Position on the Commission proposals to revise the Ecodesign & Energy Labelling measures on Washing Machines

January 2018

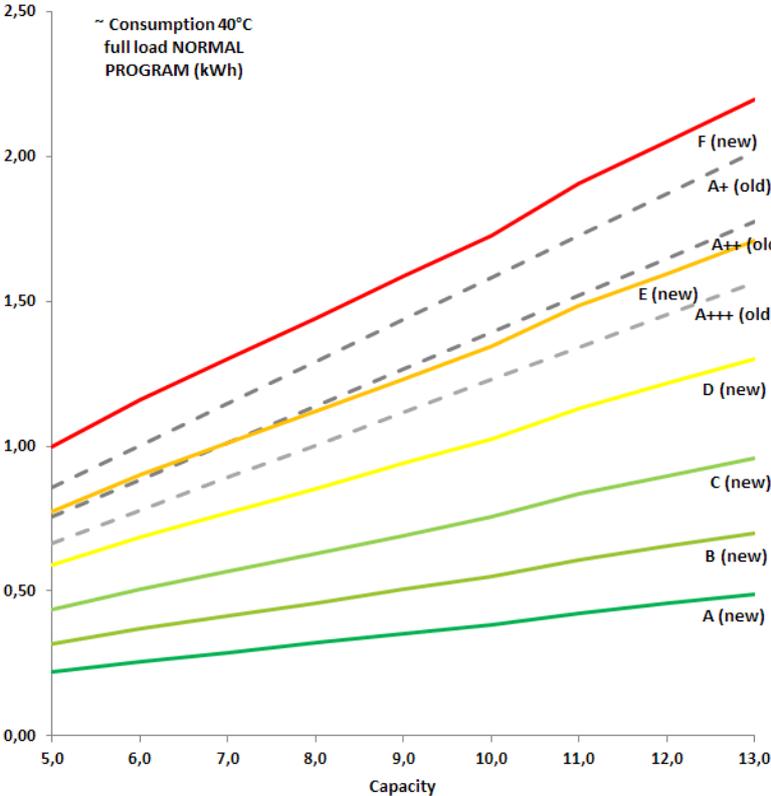
It is obviously difficult to compare the levels of current and future requirements as the metrics will substantially change and be based on different washing programmes. Yet, according to our calculations and assessment, Tier 1 energy efficiency requirements appear to be more lenient than current requirements applying since 2013, and Tier 2 is not at the level of the least life cycle-cost as calculated in the preparatory study of this review. This is illustrated in the graph below, in which we have represented the label class limits for the 40°C full load programme for a machine with load sensor (consuming 20% less at half load and 30% less at quarter load). We have taken into account that the 40°C cotton programme that will be tested in the future may consume more than the

arrowed programme with the current Regulation, by multiplying it by a 1.25 factor. This factor accounts for the fact that future programmes may be less exaggerated in terms of stretched durations and low internal temperatures.

The graph shows that a part of the proposed F class is above the current A+ class, meaning that **products that were banned since 2013 could re-enter the market at Tier 1.**

The graph also shows that Tier 2 is roughly at the level of the current A++ class, while the preparatory study calculations suggest that the least life cycle cost level (that the Regulation should aim at) is somewhere within the current A+++ class. Under the assumptions that we have made, Tier 2 is not ambitious enough.

These levels would be unacceptable, in particular the backsliding risk. We urge the European Commission to reassess the proposal and fix this potential issue by setting more adequate levels and limiting the backsliding risk.

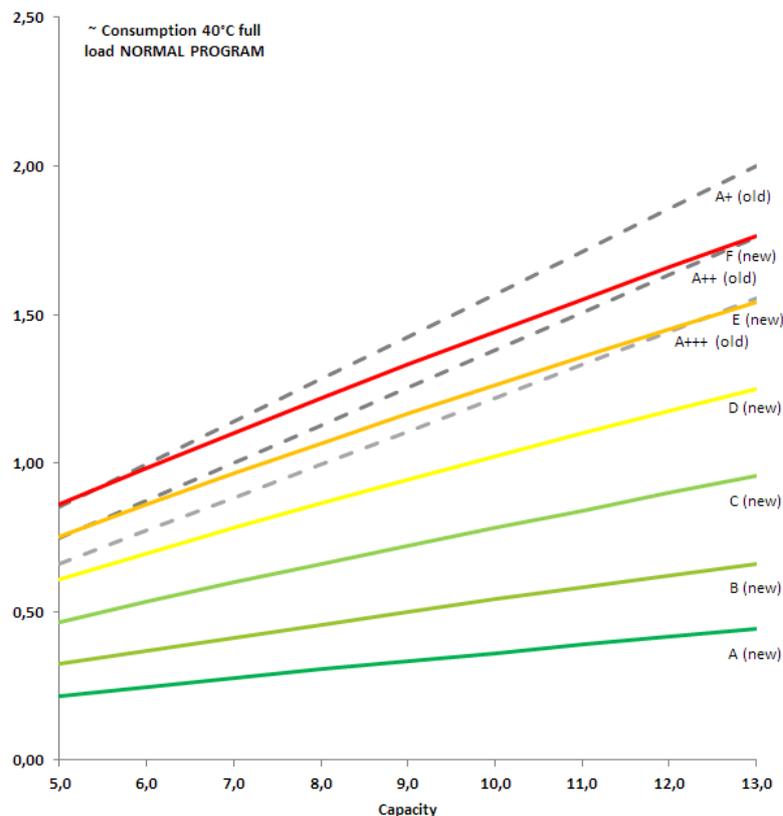
The combination of these new class boundaries with the less linear SCEc equation that we propose, and removal of the differentiated weighting factors would lead to the result as shown in the following graph.
